WHITCOMB SUBDIVISION ADDITION NUMBER 7

**ITEM #6 - PRELIMINARY PLAT
WHITCOMB SUBDIVISION ADDITION NUMBER 7**

KPB File No.	2025-068
Plat Committee Meeting:	May 27, 2025
Applicant / Owner:	Sarah Donchi and Rupert Scribner of Funny River, Alaska
Surveyor:	Jason Young / Edge Survey and Design
General Location:	Funny River Area

STAFF REPORT

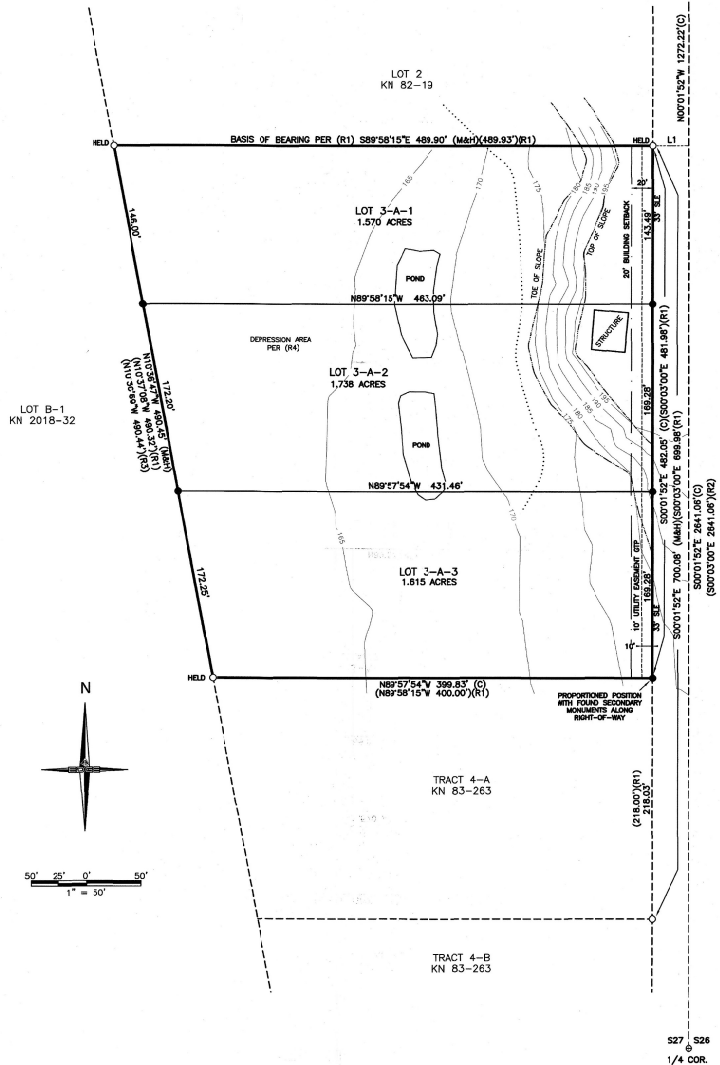
The plat is not dedicating any new right-of-way nor is it vacating any. **Staff recommends** the surveyor label James St and the right-of-way on the east side of the plat.

There is a section line easement on the east side of the plat as noted in the Certificate to Plat. **Staff recommends** the surveyor verify the easement and show it on the drawing in James St.

There is a building located on the plat, that when complete will be located on Lot 3-A-2. The Code Compliance Officer has noted that the house appears to be close to and possibly in the 20' building setback line. Per KPB Assessing information the house looks to have been built in 1982. Whitcomb Subdivision Addition No 3 KN 82-19 which created the 20' setback, did not show the house or note it at the time of platting. The structure identified on

the drawing do not look to be the same shape as the structure shown on KPB GIS data. KPB GIS aerial photo data shows two box shaped structures attached together with one being near the property line. **Staff recommends** the surveyor verify the location of the structures and the location to the front property line and inform staff if there is an issue with the structure into the building setback line. If an issue is found a Building Setback Encroachment Permit Application will need to be applied for to resolve the issue of the setback.

There are steep areas on the plat with the top and toe of slopes shown on the drawing near the east side near the road. Staff recommends the contours be removed but the top and toe of slope to remain of the finals plat.

The KWF Wetlands Assessment has identified an area of Depression classification as shown on the plat. The line notating the Depression area needs to be extended to the south line. The proper permitting note is on the plat.

The River Center review has identified the plat to be located in FEMA designated non-regulated flood zone A-unshaded requiring no depiction on the drawing. The Flood Hazard Notice as listed in KPB 20.30.280.D needs to be added to the plat notes and include the FIRM Panel and zone designation.

The parent plat Whitcomb Subdivision Addition No. 3 KN 82-19 dedicated a 20' Utility easement which was carried forward to Whitcomb Subdivision Addition No. 4 KN 83-263. The new plat needs to carry forward the 20' utility easement which is currently being shown as a 10' utility easement. **Staff recommends** the change as noted.

Plat note 6 list easements in Homer Recording District Vol 30 Page 53 is unreadable, Inst 2003-001884-0 is in Sec 14, T4S, R15W release Vol 30 Page 53, this does not appear to affect this plat and can be removed.

Modify the KPB File to 2025-068

Change Lot 4-A in the legal description to 3-A

Parent plat filing is KN 83-263

Add the road name of James St and right-of-way width on the road.

Verify and add the section line easement as per CTP #6, in James St.

Add the name of James St and 66' ROW to the drawing

Parent Plat Whitcomb Subdivision Addition No. # KN82-19 granted a 20' Utility Easement that was carried forward to KN 83-263 and needs to be carried forward to this plat.

Parcel to the west needs corrected to Lot 1B

Parcels to the south need corrected to Lots rather than tracts

Parcel to the north needs Block 1 added to the lot label.
